# Conceptual Review Agenda

Schedule for 09/26/16 to 09/26/16

# 3555 Stanford Dr. Addition

December 05, 2016

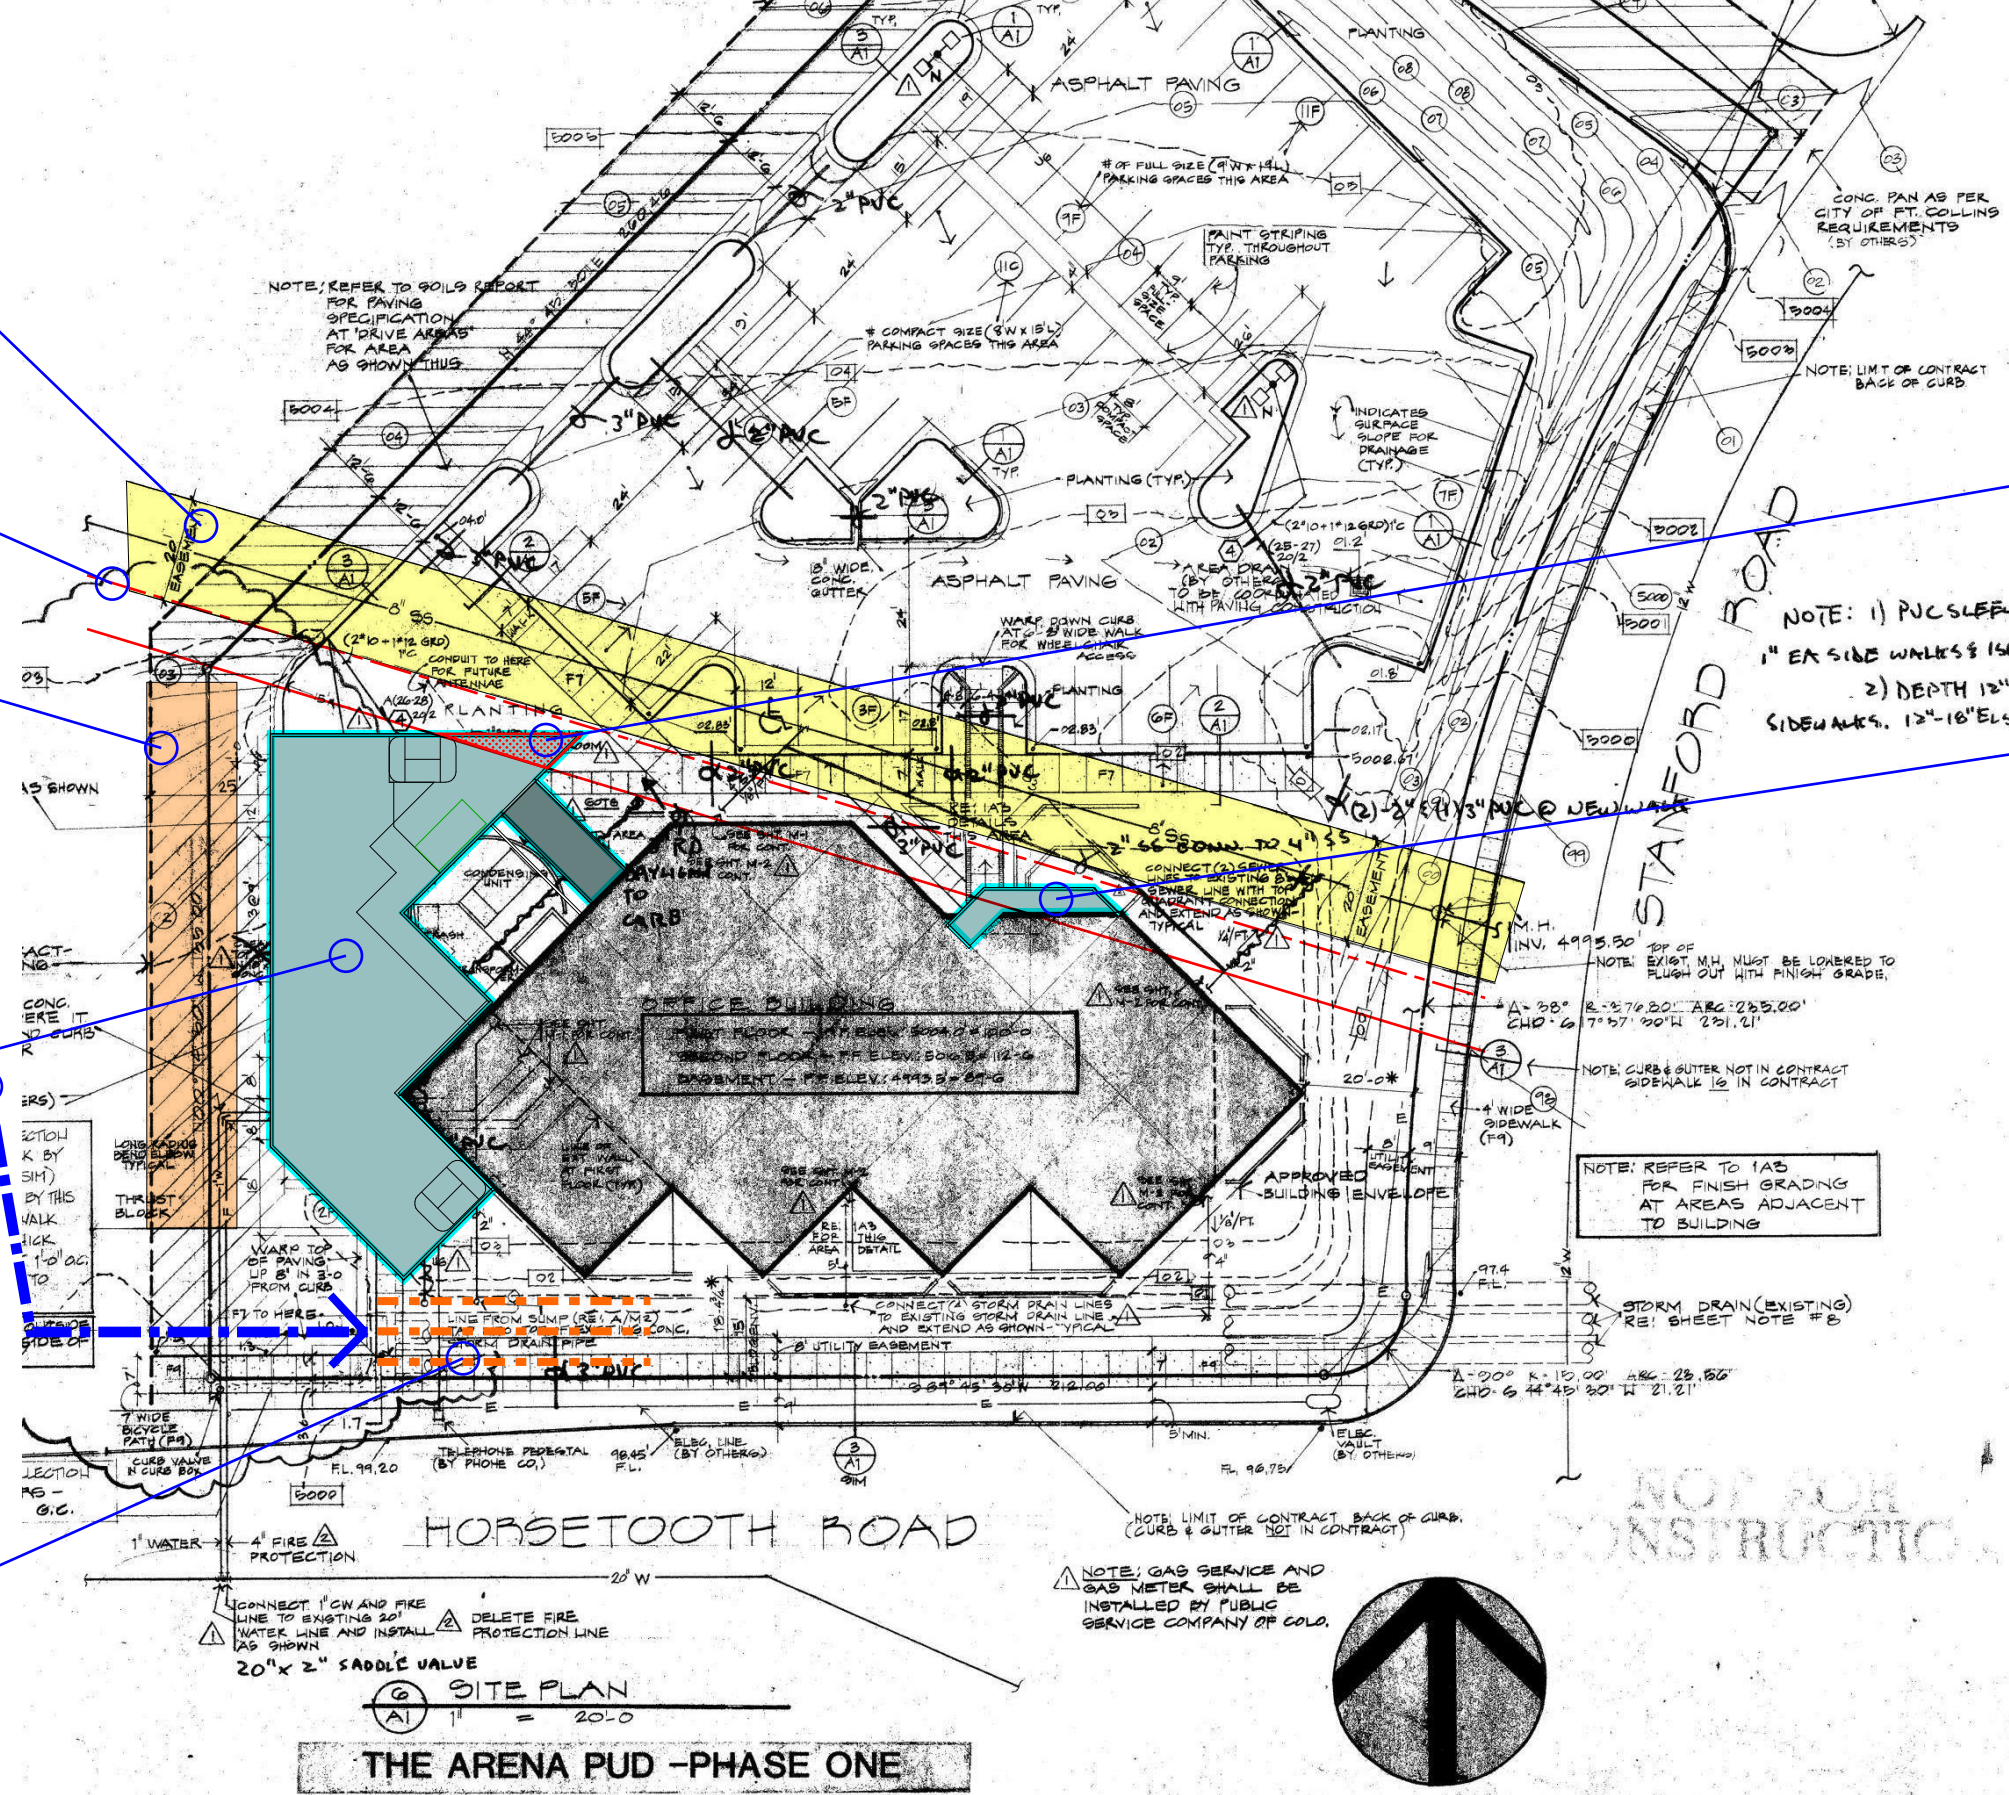
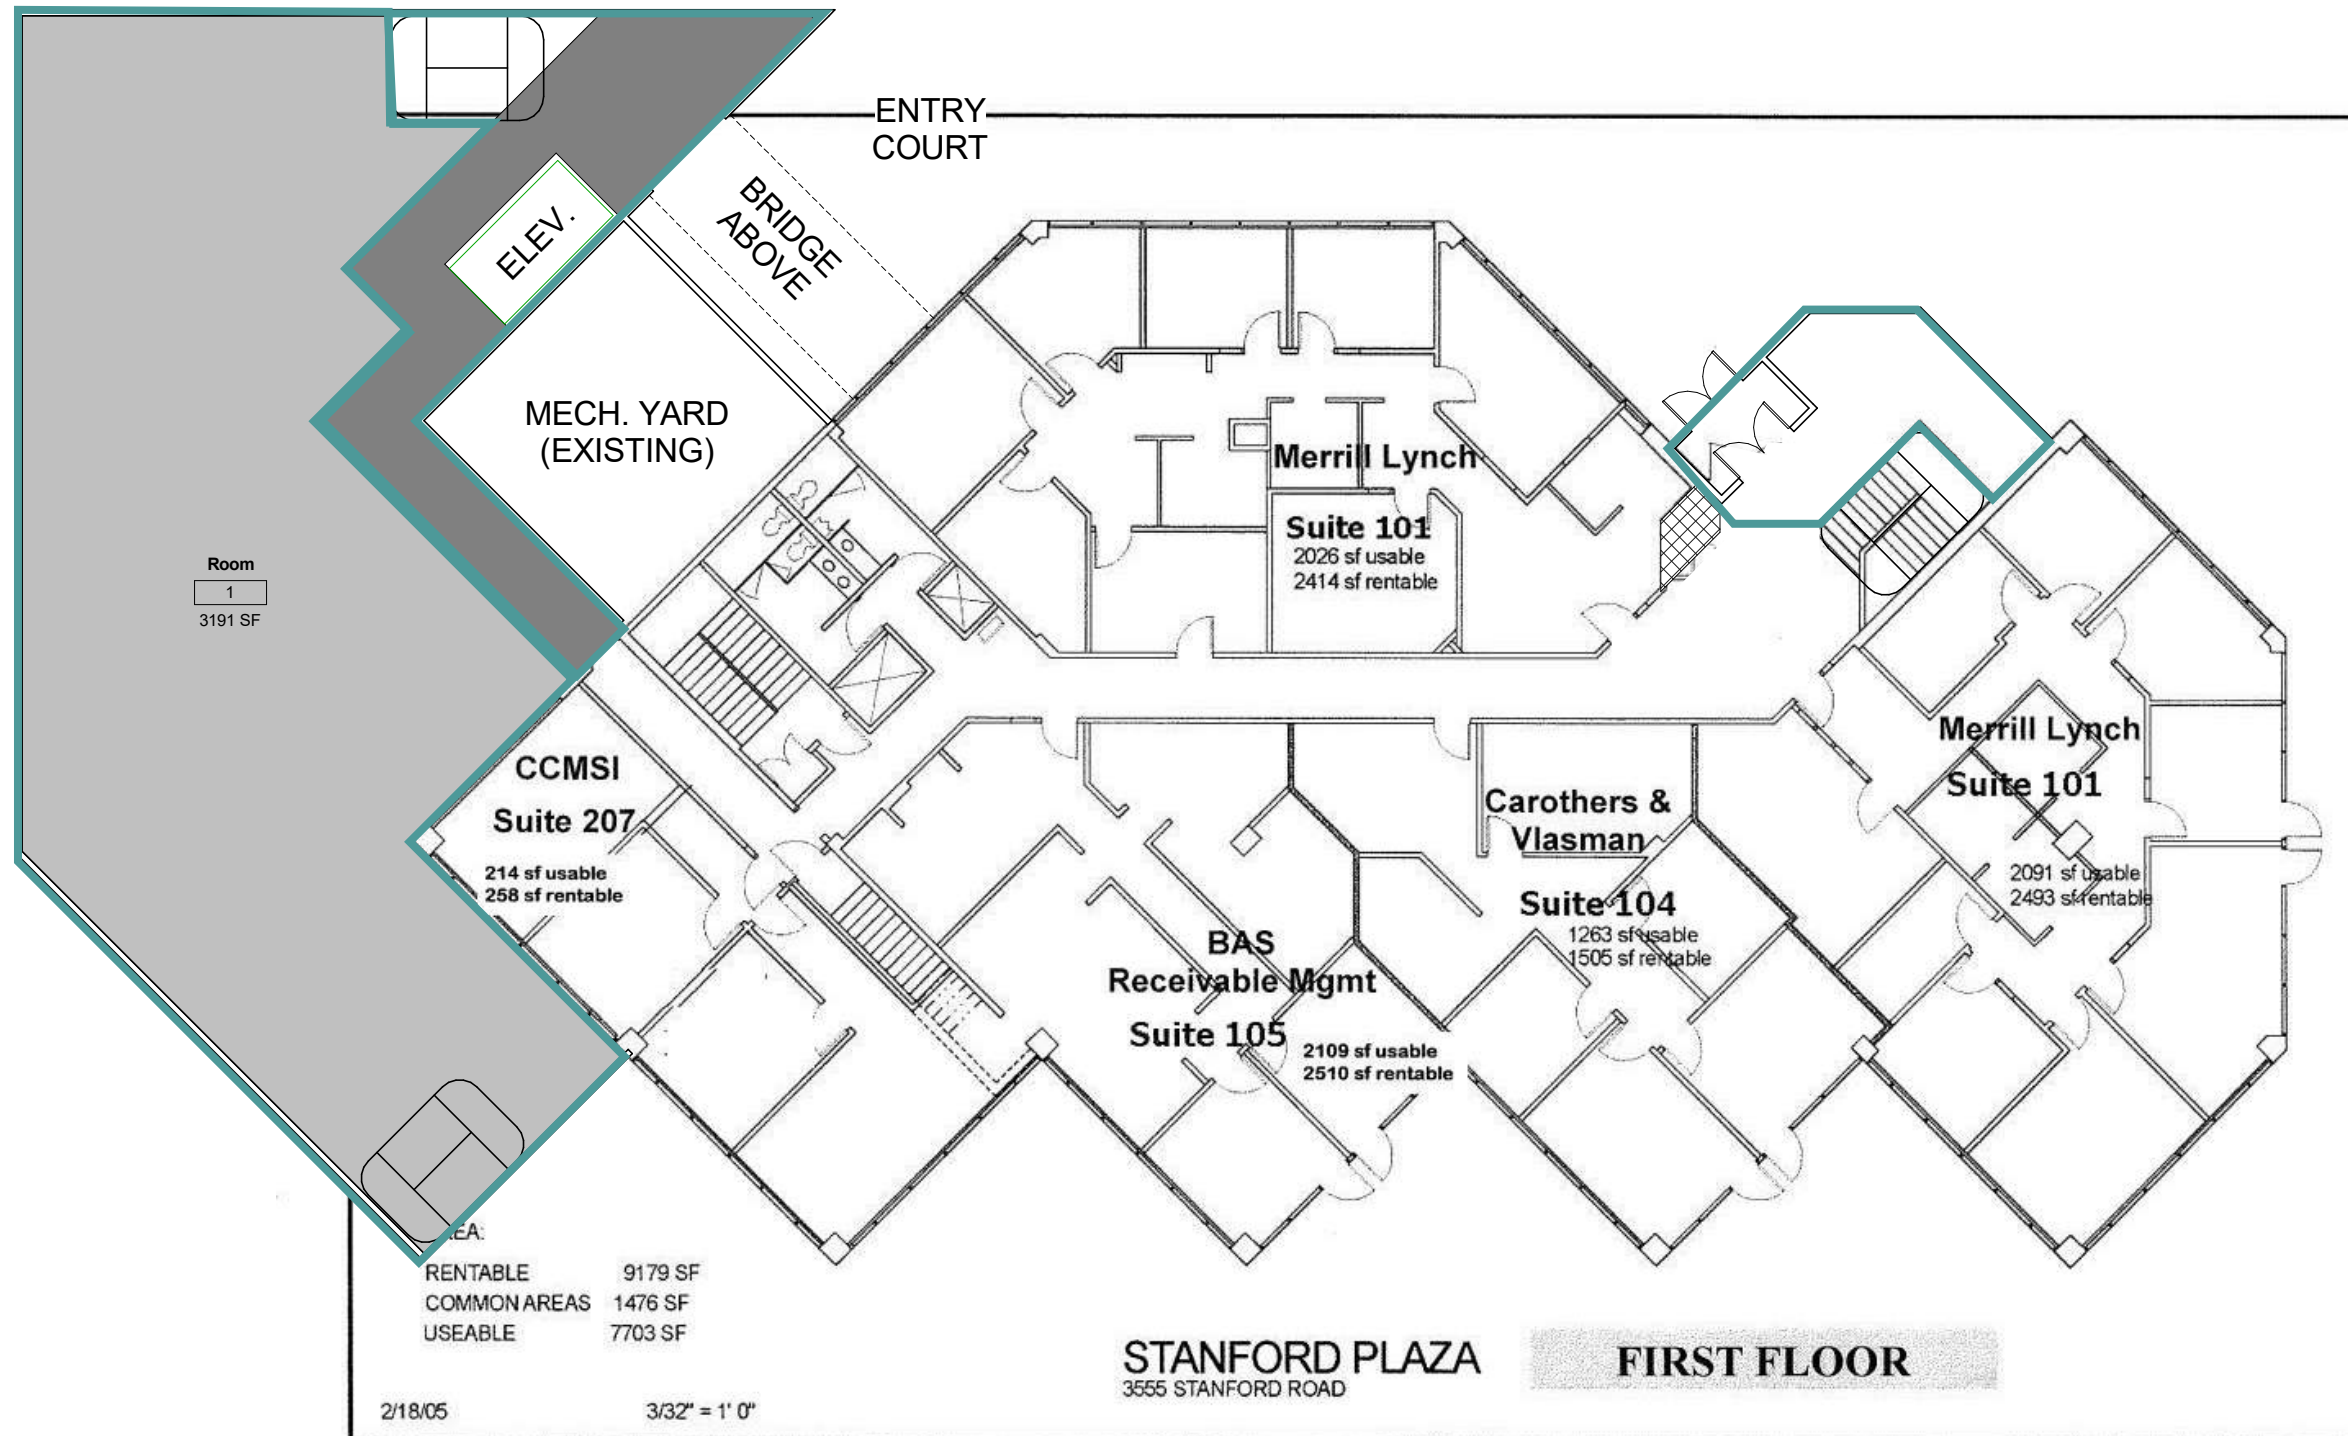
3. The provided exhibit indicates that you plan to re-route the existing storm pipes around the building addition. This is fine as long as there is sufficient slope (typical minimum slope on storm pipes is 0.40%) on the re-routed pipes and as long as drainage easements are dedicated along the new alignment. Also, we will want to make sure that all public stormwater pipes within this property are within a drainage easement, so if an easement
